CITY OF SOMERVILLE, MASSACHUSETTS
OFFICE OF STRATEGIC PLANNING & COMMUNITY DEVELOPMENT
JOSEPH A. CURTATONE
MAYOR

HISTORIC PRESERVATION COMMISSION

ALTERATION TO A HISTORIC PROPERTY STAFF REPORT

Site: 21 College Hill Road c.1850 Thomas Cook House
Case: HPC 2013.083 Single-Building Local Historic District

21 College Hill Road showing location of chimney for the proposed vent cap.

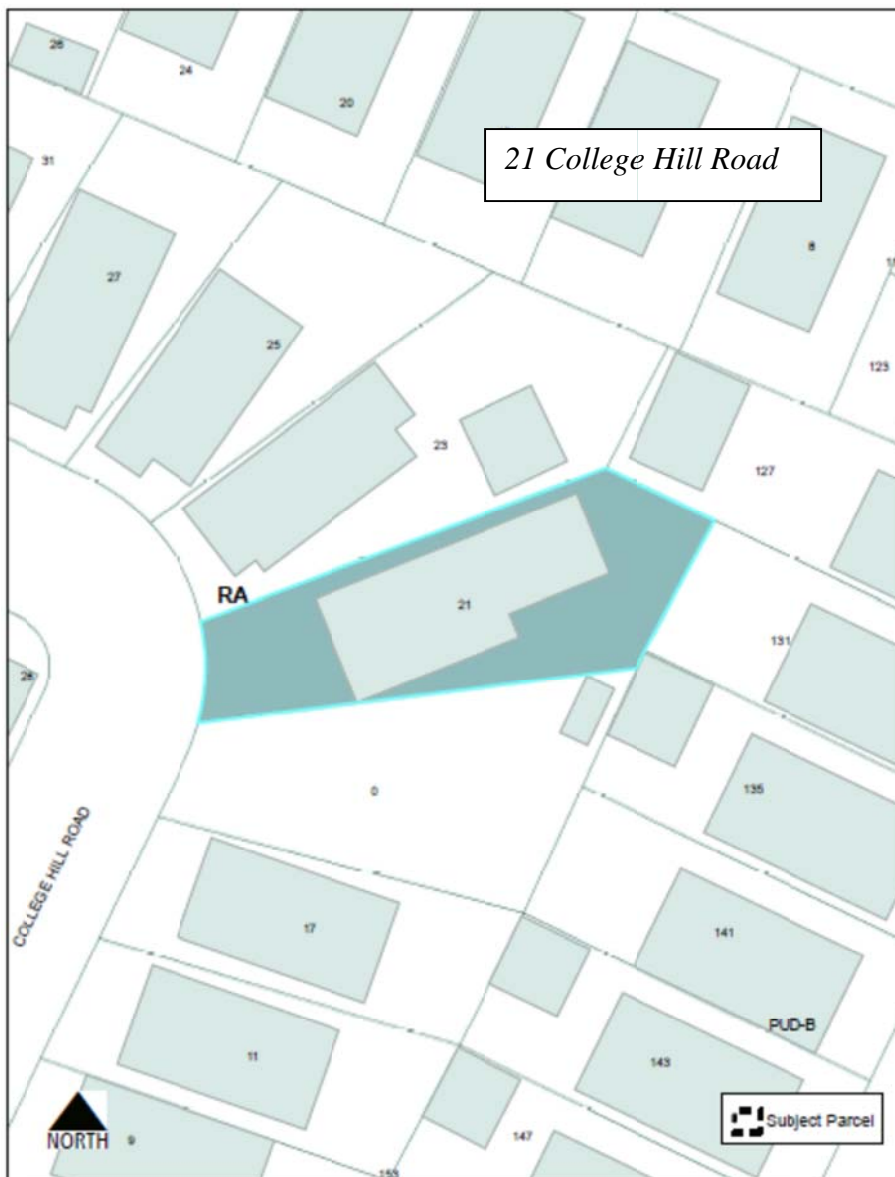
The chimney cap would be visible from College Hill Road while approaching the house from North Street but not from the other direction. It would be located on the second chimney visible from the road.

The chimney has deteriorated and is the in use for the hot water and heating. Interior repairs are being made which include relining to bring the chimney up to code and the installation of the needed chimney cap. See photos at the end of the document.

The proposed cap would be in a dark finish either black or copper and stylistically very simple so as to not detract from the existing chimneys.

1. Install a black or copper termination cap on top of the existing center chimney.
